## TOLEDO - LUCAS COUNTY PLAN COMMISSIONS

REF: SUP24-0010

SUBJECT: Special Use Permit for Stand-Alone Solar Array at 0 Dura Avenue

Request	-	Special Use Permit for stand-alone solar array
Location	-	0 Dura Avenue
Applicant / Developer	-	Project Beacon, LLC 5100 W. Central Avenue Toledo, OH 43615
Engineer	-	Verdantas 219 S. Erie Street Toledo, OH 43604

# SITE PLAN 1

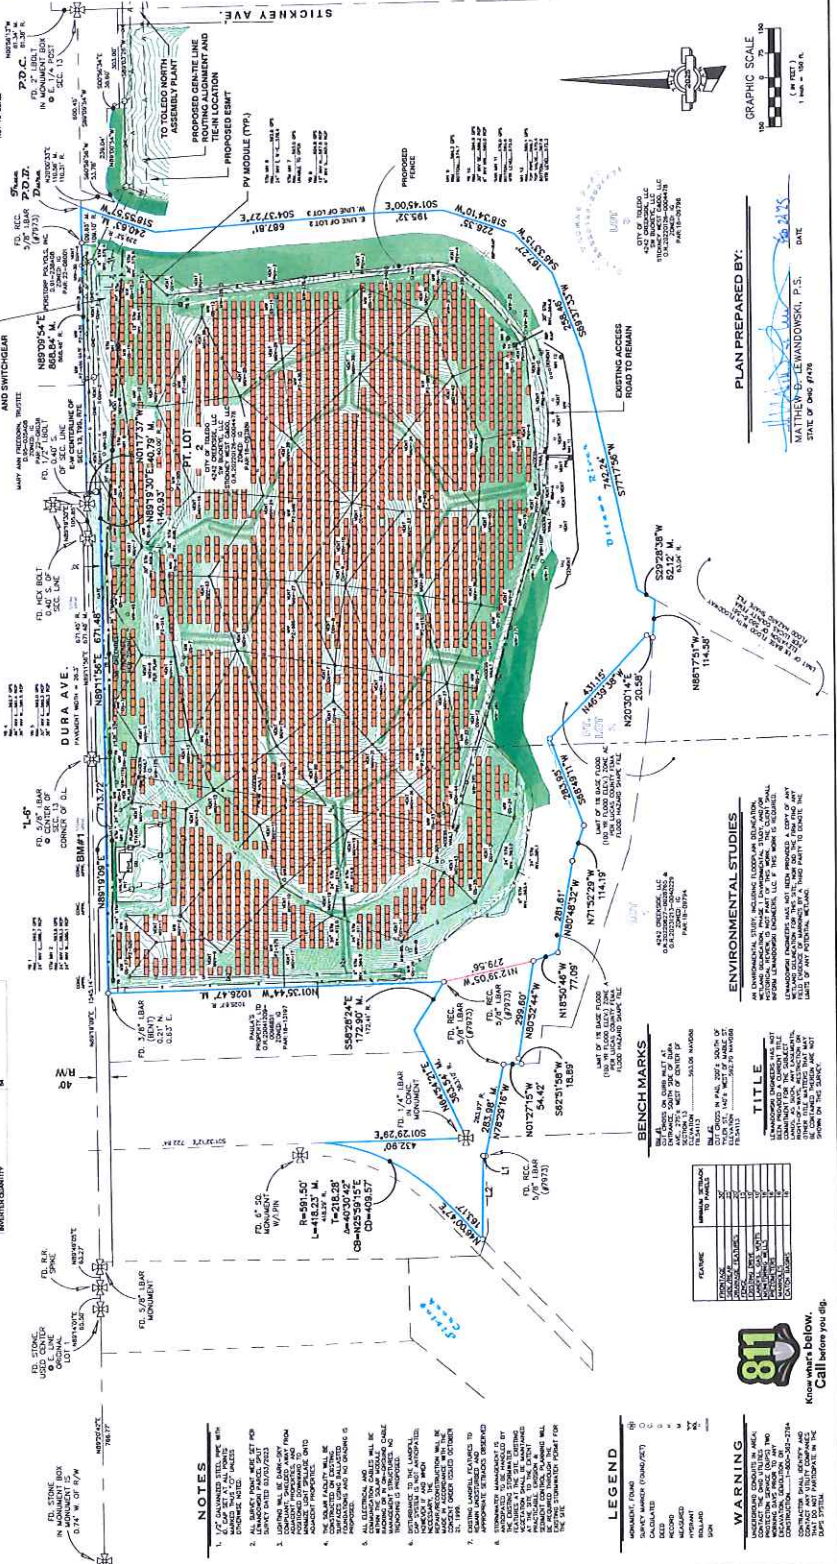
The site plan depicts access roads throughout the site. Per TMC§1107.1906 - Surfacing and Drainage, maneuvering areas, aisles and driveways must be surfaced with concrete, bituminous asphalt, or other dust-free material other than gravel or loose fill, and be graded to drain all surface water towards the interior of the parking lot. Since the site plan indicates that there will not be any disturbance to the landfill cap system, it is assumed that the access road will not be surfaced with concrete or asphalt. As such, the applicant will need to secure a waiver from this requirement.

Sites over five (5) acres are required to provide a thirty-foot (30') frontage greenbelt along the right-of-way per TMC§1108.0202 - Frontage Greenbelts. The frontage greenbelt shall include at least one (1) tree for every thirty-foot (30') of lot frontage. The submitted site plan depicts a thirty-foot (30') wide frontage greenbelt along Dura Avenue; however, a landscape plan has not been submitted that illustrates the required fifty (50) trees. Staff acknowledges that the site is intended for solar energy generation and trees can interfere with this. The applicant will need to secure a waiver from this requirement.

The site plan submitted depicts a seven-foot (7') Bekaert solidlock game fence, with wood posts and steel posts on the corners/ends, surrounding the solar arrays on all sides. This includes the area along Dura Avenue within the thirty-foot (30') front yard. The Engineer for the project has noted that the Applicant is in fact not proposing this type of fence, but is instead proposing a seven-foot (7') high chain link fence with barbed wire as currently exists along Dura Avenue. Per TMC§1105.0302(1), fences may not exceed 3½ feet in the front yard for all Industrial zoning districts. In addition per TMC§1105.0303, the use of barbed wire, razor wire, concertina wire, and electric fences are only permitted in Industrial districts and then only in the side and rear yards when not within 50 feet of a Residential district. Barbed wire, razor wire, concertina wire, and electric fences are also not permitted in the front yard or anywhere along a street right-of-way. The applicant shall secure a waiver to the applicable code sections to allow for the proposed fence height and type in the required front yard along Dura Avenue. Additionally as a condition of approval, the site plan shall be revised to reflect the correct type of fence material proposed.

5. A SWP3 submittal is required; note 8 on each sheet of the proposed site plan is insufficient to meet the requirement, since a 513 permit for one of the landfills is the only document that calls out surface water management, and the requirements of the 513 are not known to be to the standards of the Ohio Construction General Permit. Toledo requires a SWP3 for projects over 2,500 square feet of construction activity. Placement of the fill (ballast) would constitute a construction activity. The total disturbance of the project would not just be the footprint of the ballasts however and would also include the remainder of the area that will be disturbed by construction activities, including construction traffic. If any of the site is to experience heavy construction traffic from equipment and will disturb the earth, that would need to be accounted for in the calculation of the total disturbed area. The entire project including the electrical transmission work offsite will need tallied, and if greater than an acre, an NOI will also be need to be submitted and authorized by OEPA.

7. Provide 60 ft wide clear space above the 36" storm and 42" sanitary sewers.

23. Off-street parking and loading spaces, parking lots, maneuvering areas, aisles and driveways must be surfaced with concrete, bituminous asphalt, or other dust-free material other than gravel or loose fill, and be graded to drain all surface water towards the interior of the parking lot. **Not acceptable as submitted.** Applicant shall obtain a waiver to TMC§1107.1906, so that the internal access roads do not have to be surfaced with concrete, asphalt or other dust-free material.

- a. A thirty-foot (30') frontage greenbelt is required along Dura Avenue and shall include one (1) tree per every thirty-foot (30') of frontage. Fifty (50) trees are required. A landscape plan has not been submitted. **Not acceptable as submitted.** Applicant shall obtain waiver to TMC§1108.0202(B)(1), to allow for landscaping as approved by the Plan Director, in lieu of the fifty (50) trees required along Dura Avenue. In addition, a landscape plan depicting the proposed landscaping shall be submitted.

- e. The location, height and materials for any fencing to be installed and maintained. **Not acceptable as submitted.** The applicant shall obtain a waiver to TMC§1105.0302(A)(1) and TMC§1105.0303 for the existing and proposed chain link fence with barbed wire in the required front yard along Dura Avenue. Additionally, the site plan shall be revised to reflect the correct type of fence material proposed.

Approve a waiver so that the proposed access roads for the solar energy facility do not have to be surfaced with concrete, asphalt or other dust-free material. Staff is in support of the waiver as the access roads will have minimal use once the facility is constructed.

Approve a waiver to allow landscaping, as approved by the Plan Director, in lieu of the fifty (50) trees required along Dura Avenue. Staff is in support of the waiver as large shade trees may interfere with the collection of solar energy on the site.

Approve a waiver to allow for a seven-foot (7') high fence in the front yard along Dura Avenue. Staff is in support of this waiver due to the nature of the proposed use and the need for site safety and security. Additionally, the adjacent property and the property along the north side of Dura Avenue is zoned and used for industrial purposes.

Approve a waiver to allow for a chain link fence with barbed wire in the front yard along Dura Avenue. Staff is in support of this waiver due to the nature of the proposed use and the need for site safety and security. Additionally, the adjacent property and the property along the north side of Dura Avenue is zoned and used for industrial purposes.
